Technical Information

Y08765

Title	Change of Motor assembly with Air pipe assembly
Model	MP100D
Country	All countries
Description	[1][2] Air pipe assemblies for production have been unified to ø6mm thread type. [3][4] Motor assembly for production have been changed according to [1][2]. Note: There is no difference in performance between ø6mm thread type and ø8mm thread type. However, the repairs are different. See below.

ø8mm thread ø6mm thread

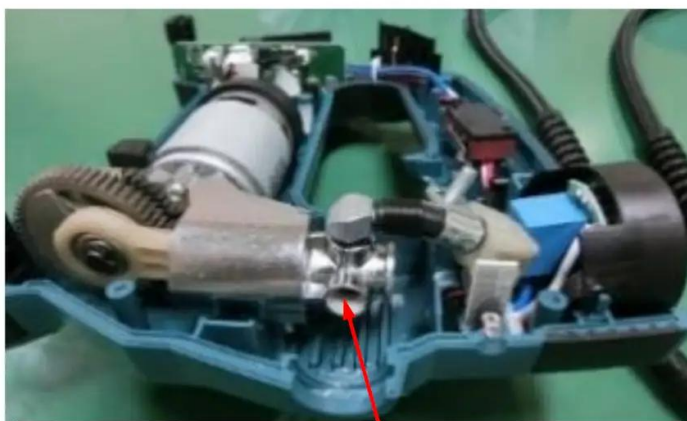
Current Air pipe assembly has either ø8mm or ø6mm threaded air pipe end as shown above.

New Air pipe assembly has the only ø6mm threaded air pipe end.

Only Air pipe assembly wants to be replaced;

Check the thread diameter of the machine that the customer repairs, and order the same Air pipe assembly.

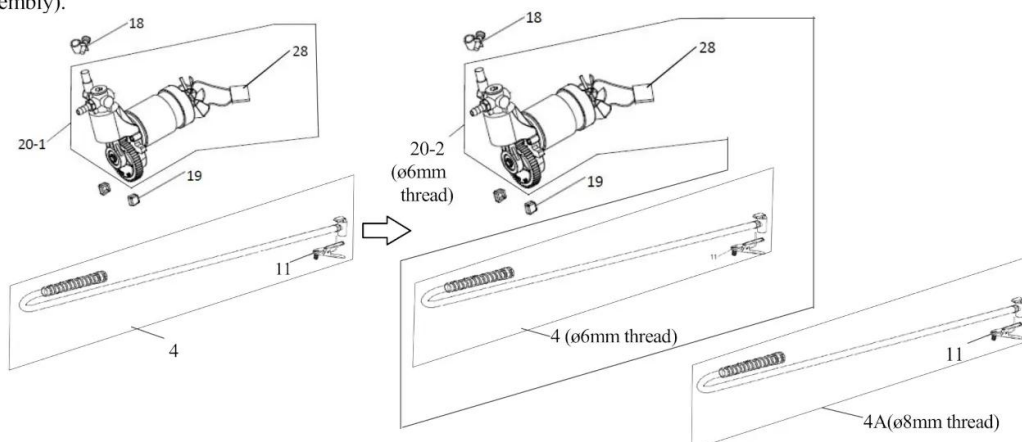
Current Motor assembly has either ø8mm or ø6mm thread joint portion.

New Motor assembly has the only ø6mm thread joint portion.

Motor assembly wants to be replaced;

Because of parts unification to ø6mm thread type, order the new Motor assembly (with ø6mm thread Air pipe assembly).
